Target and Dump Proton Beam Imaging Systems CDR

Target System CAD Integration

This document describes the process that has taken place for the CAD integration of optical system inside the PBIP (Proton Beam Instrument Plug) and the target connection cell.

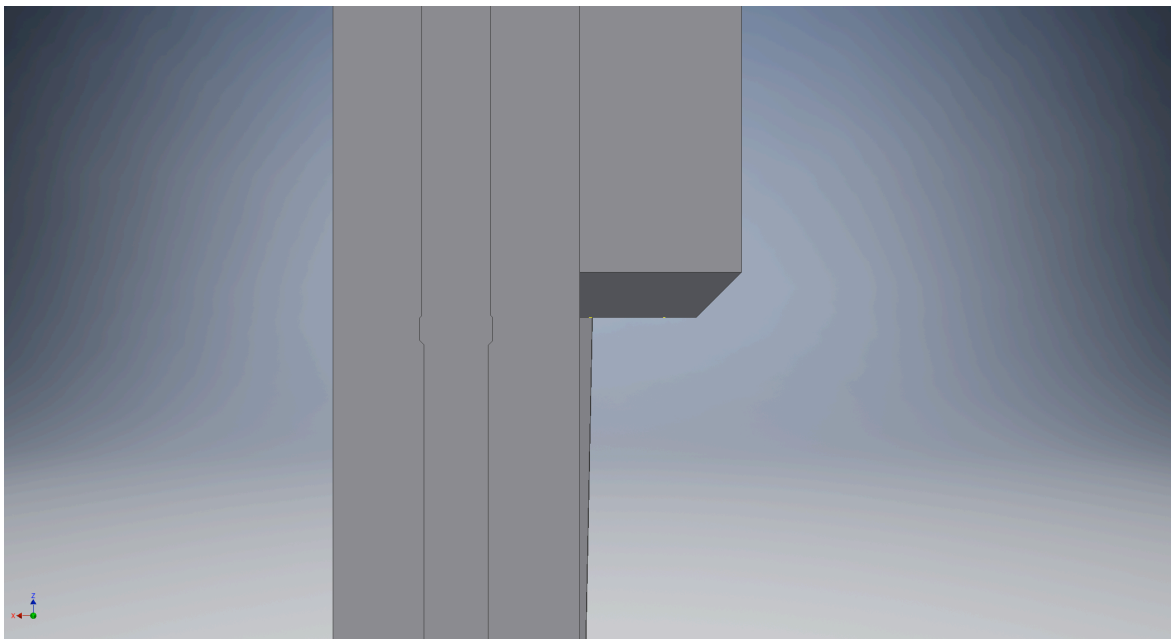
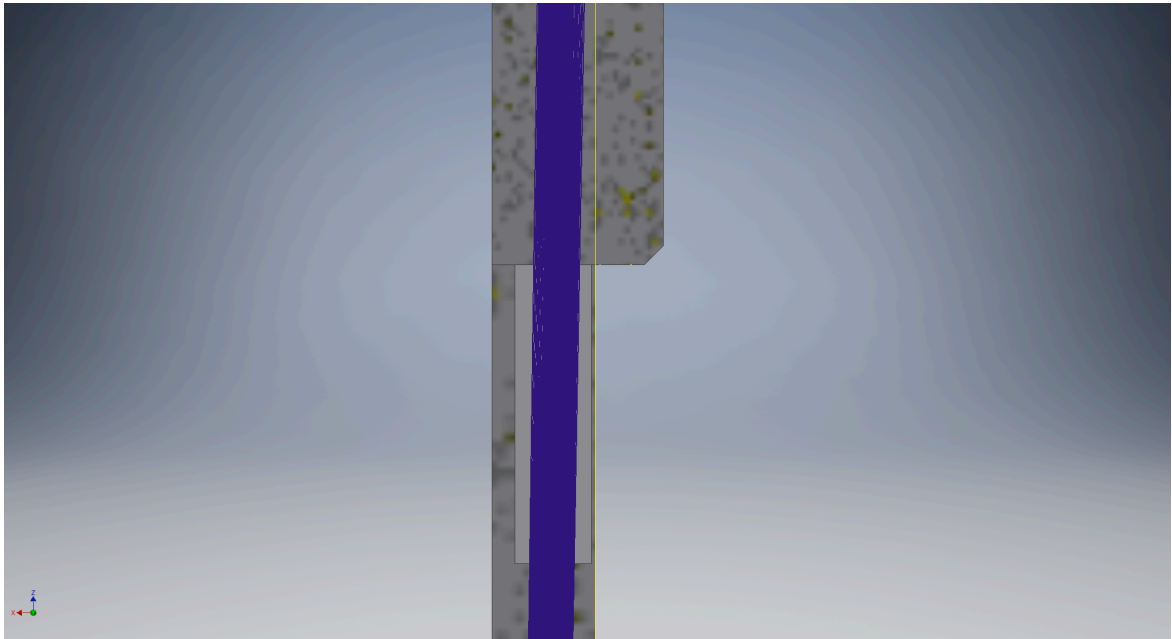
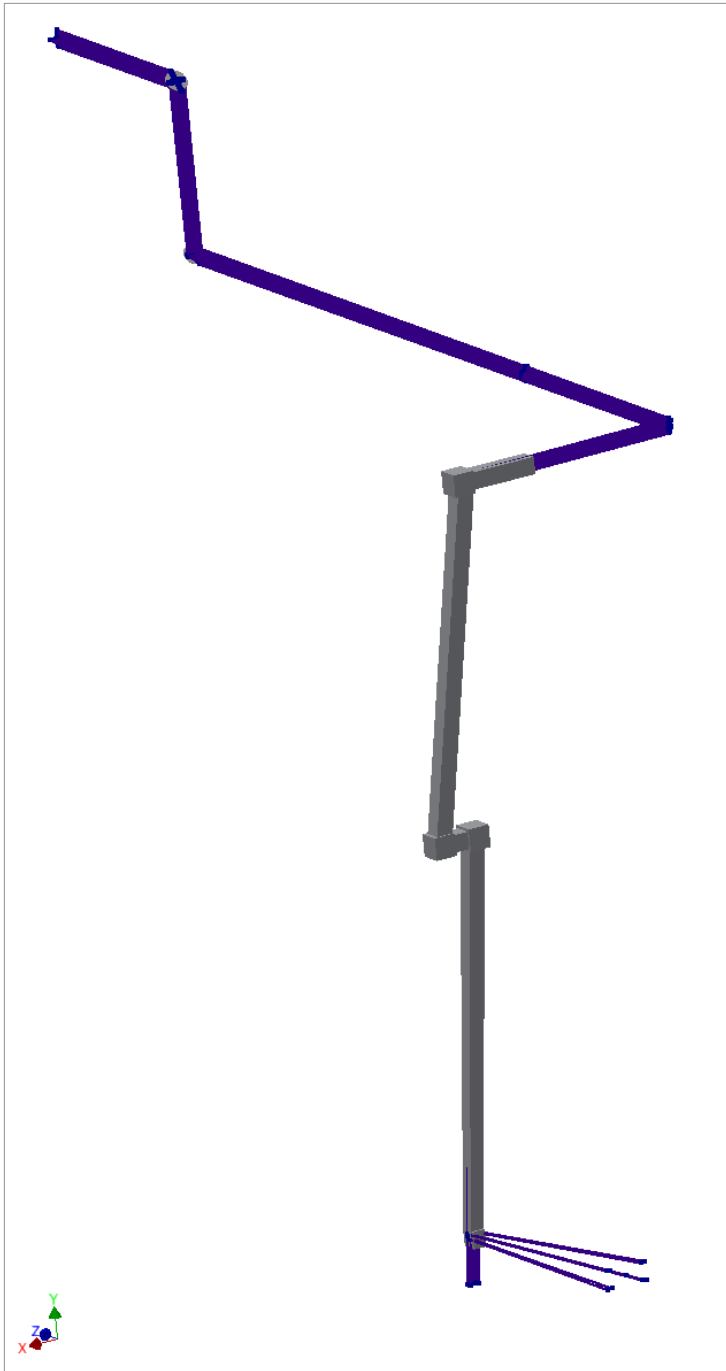
New beam path fits much better into the plug, compared to the previous beam path, but one of the space marking boxes lies slightly outside the plug (5,5 mm)

To solve conflict, (1546mm instead of 1540mm)

Small adjustments – no conflict

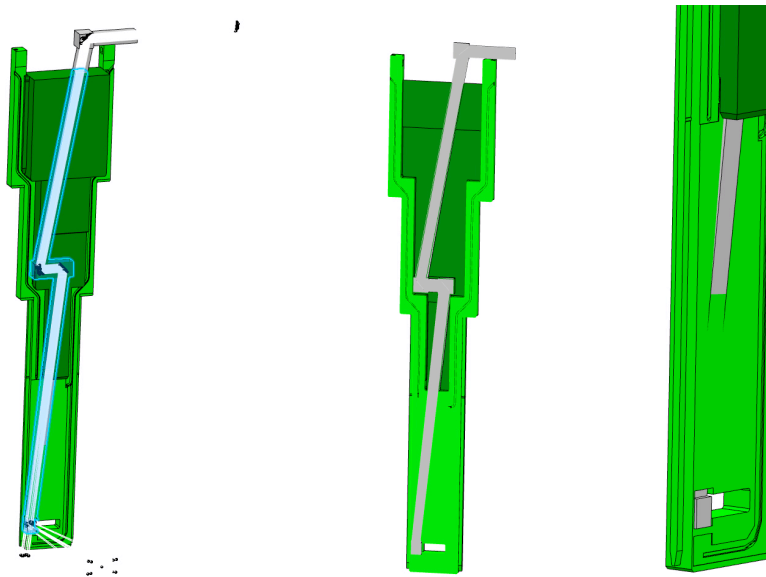
The volume around the rays is sticking out a bit from the front of the (lower) Slice Body, but the rays “stay inside” the optical blocks of the PBIP.

We will make adjustments, so that the volume does not stick out.

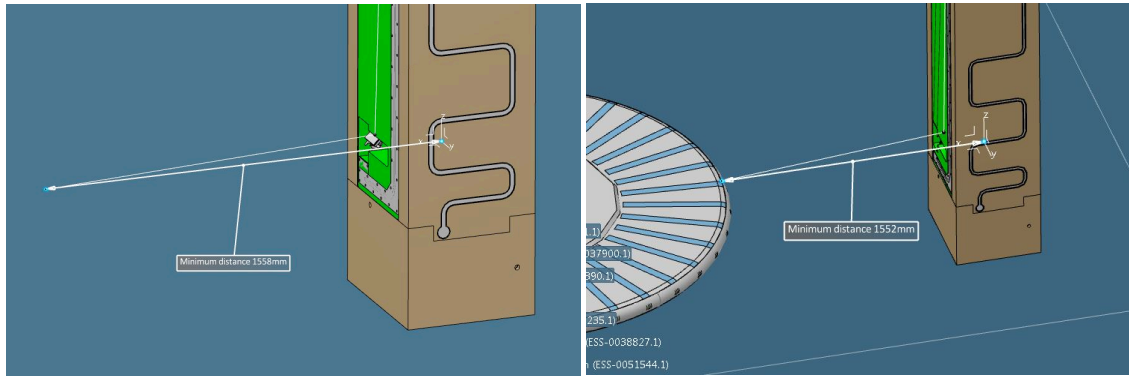
This afternoon when I "double checked" our PBIP models with included Optics I discovered an important deviation:

The center of the object is not at the same position in X-direction when we compare "Maren's model" and "my model"!

There is a deviation of $\Delta x = 6$ mm
As an illustration I add two pictures.

You are right. The difference is due to us moving the optical path forward as a CAD object, and me not adjusting the distance to the target in Zemax afterwards.

The error in the angle for the first mirror is about half an mrad, but I will send you an updated CAD file of the mirrors + central ray so that you have them Monday morning.

Hello Reinhard,
Attached is a STEP file with the object 6 mm closer to the mirror.

I have also attached step file of the mirrors, including ray. (Se figure "Capture_final-PBIP-mirror-positions2_2 ")

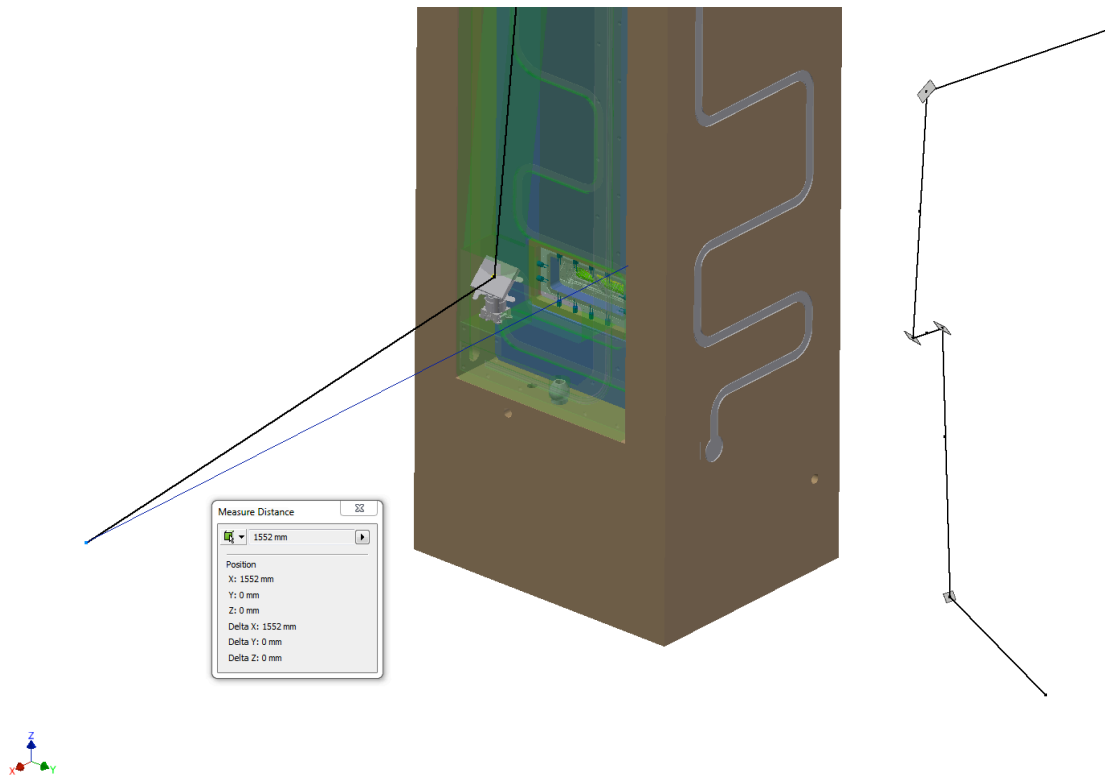
The step file "integrated" that was sent to you yesterday (27. Sep) , has wrong location of mirrors relative to the PBIP.

Attached is new model (PBIP_n_mirror_positions_377_28_Feb_2). This new model has both correct location of mirrors inside the PBIP and correct distance to curved edge of the Target Wheel (1552 mm)

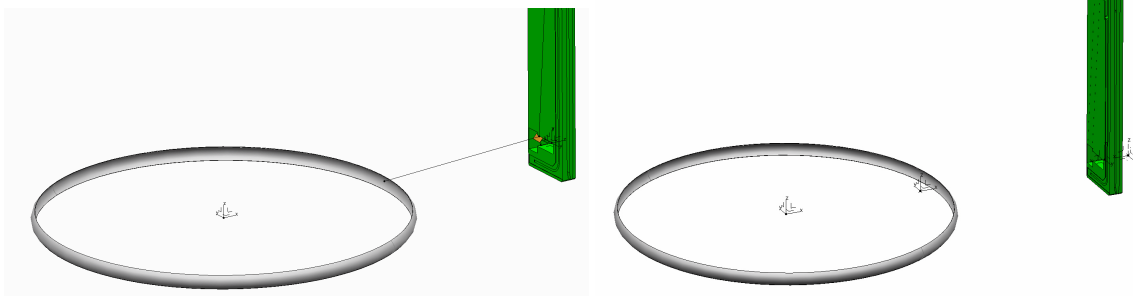
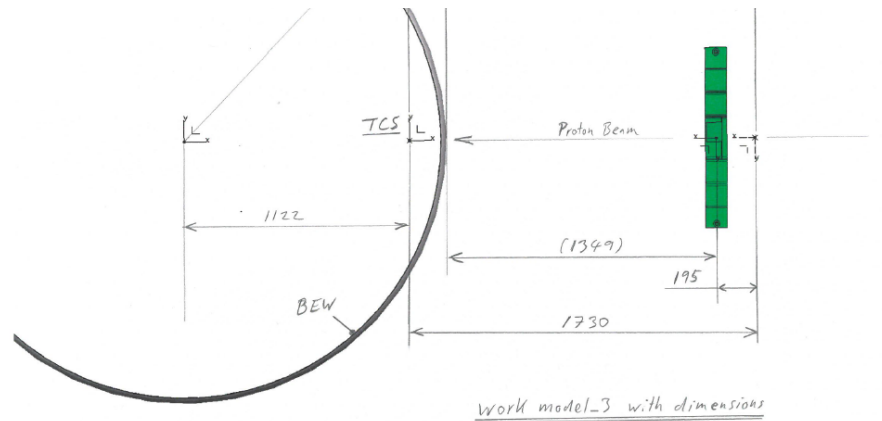
1) Position of Object (first point on ray) in relation to the rim:

The object position in the latest design is 8 mm inside of the rim. Is this ok, regarded the curved surface of the rim?

Must we consider the layout of planned fiducials on the outside of the rim?

2) Anchoring of Optics relative to PBIP:

Now the Origin of the Optics is situated on the x-axis with 195 mm offset from the origin of the PBIP. This is all right for me. (The second point on ray is situated 158 mm sideways from the Optics origin.)

1) The short answer here is that the exact depth does not matter a lot.

The length of the ray from the first mirror to the rim can be adjusted by turning the focus ring on our lens, but the direction of it is fixed by alignment. If the direction is bad, it means the image is not well centered in the PBIP aperture. The lateral shift away from the true center of the BEW that comes from missing it by 8mm in depth, means that the direction is off by less than an mrad, which is small compared to the tolerances we have from installation.

(69 PBIP Optics in Building)

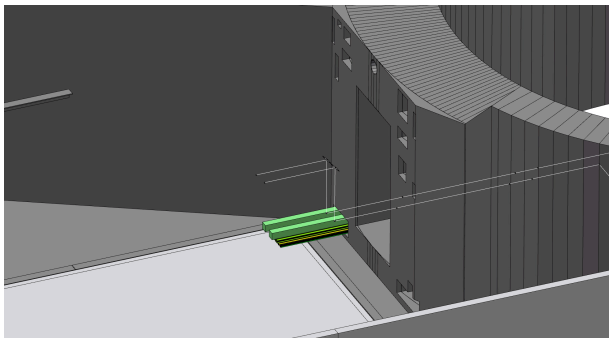
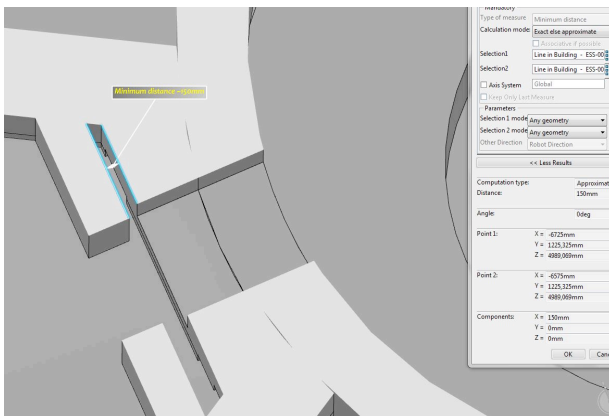
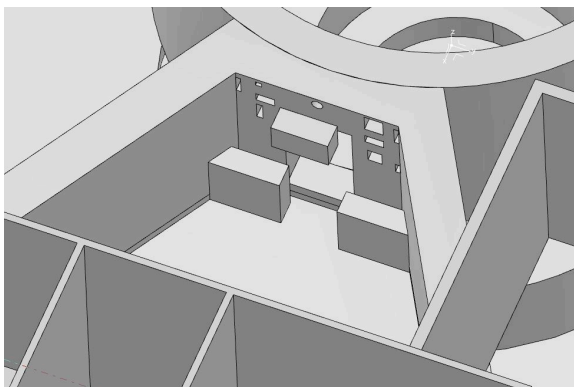
Thanks for your mail with the latest optics design last week. I have implemented your design into our model and checked with the building model. As we can see in pic 69 the rays end up quite good in room D02.115.4005 ("Tom's room"). But when I compare with another preliminary building model that even contains supplementary shield walls in Tom's room, I would say that further investigation is needed (see pic 70 and 71).

Is the position of the main shield wall the same in both models? If so, I could adjust the path so that the mirrors are a little closer to it. 150mm should be sufficient space for the mirrors and path.

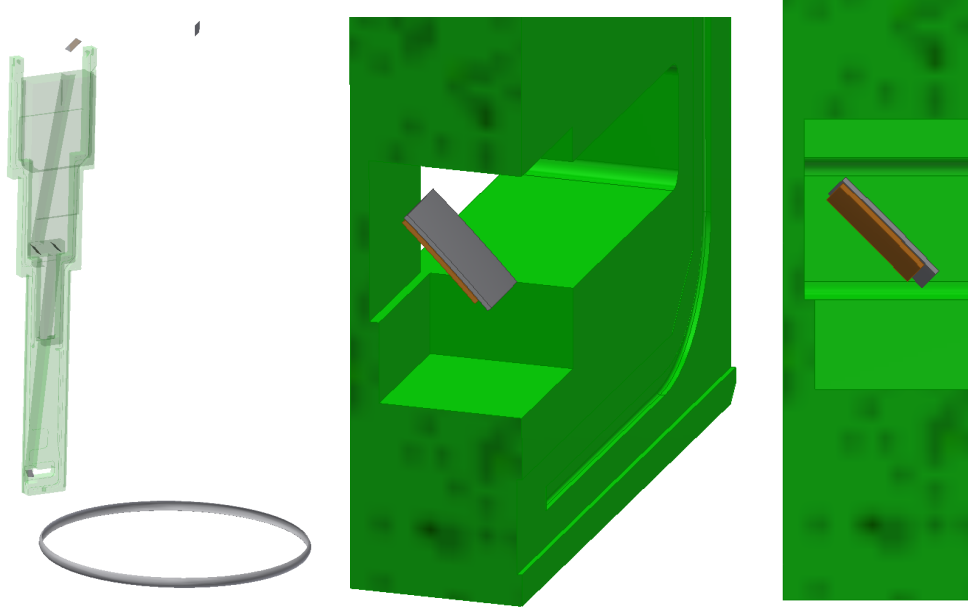
Mirror 1 has been modified in size, and the mirror position has been shifted towards to opening in the Plug. Old mirror size and position in orange color, new in gray color. (Model: work model_4-2017-09-26 with TW-CDR from Håvard)

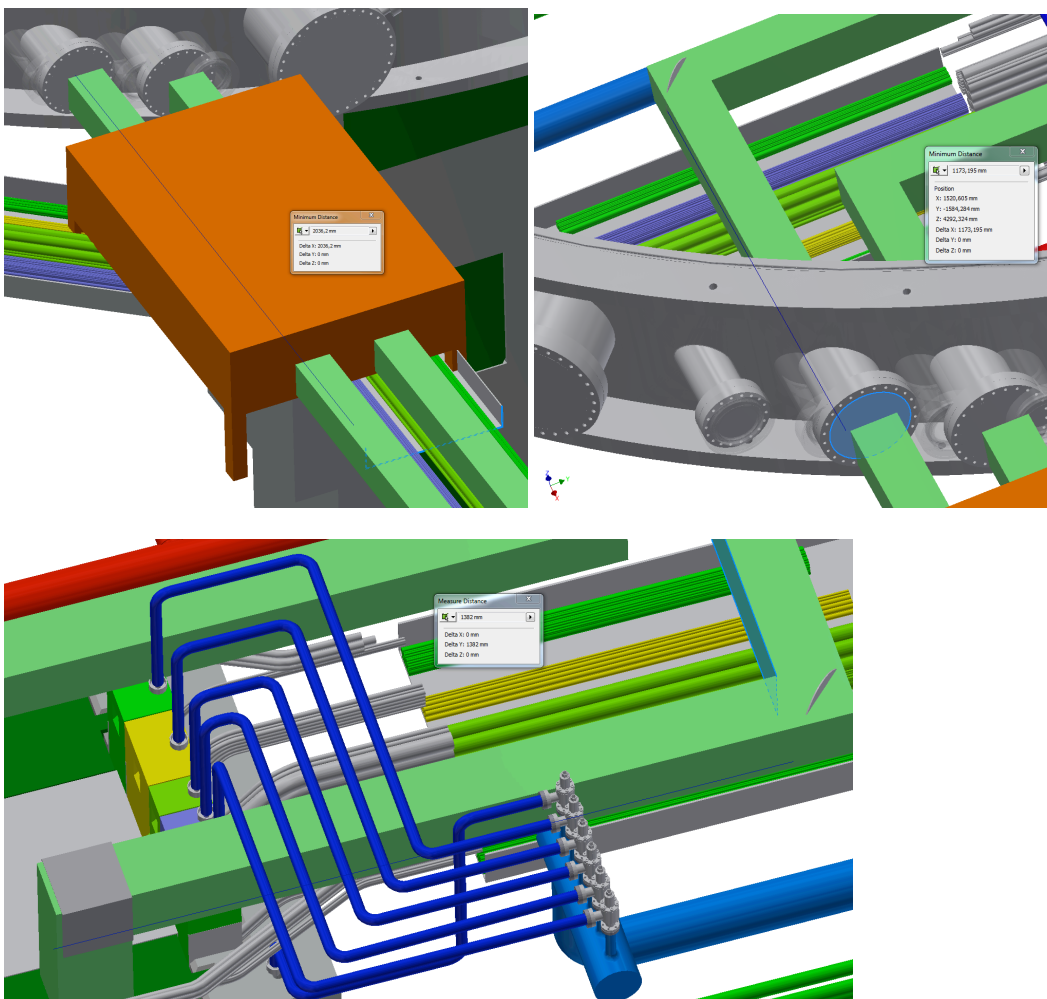
- Distance from mirror on top PBIP to the mirror that guide us in direction of the camera is now larger.
 - How much must the mirror be moved?
- The optical path through connection cell must also be moved, including tables and equipment. Is the distance between the two optical paths larger than earlier?
 - Might need to enlarge the table.
- Vacuum tube shall be included in the newest model.
 - After model has been updated with new table position and size, is it space for the lens next to the path?

For distance out from wall, (31Jan_3), 62,5 mm must be added (total distance of approx. 210 cm.)

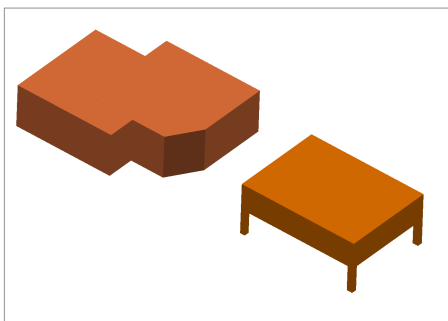
1. It seems like you are using an old model of the connection ring. In the current model the flanges for the optic paths are changed from DN100 to DN150, they are also moved a bit in order to fit. See the pictures below.
2. Your space claims are quite big. Inside the monolith vessel, right next to the PBIP, there are a lot of piping and cabling as you can see in the picture below (in this picture you can see both the DN100 and the DN 150 flanges). We cannot give you this much space, you need to decrease the size of your boxes. Can you explain why you need all this space?
3. There is probably a collision between the optic table in the connection cell and the big vacuum pipe you see in the picture below. Maybe this will be ok when the latest model with DN150 flanges are used.

It seems to be some mistake in the communication, the change in the connection cell were made in the middle of November about the same time as when we exchanged models. I am sorry for any inconvenience this may have caused you. Stig will send you a step file containing the latest model of the connection ring, he will also include the vacuum pipe.
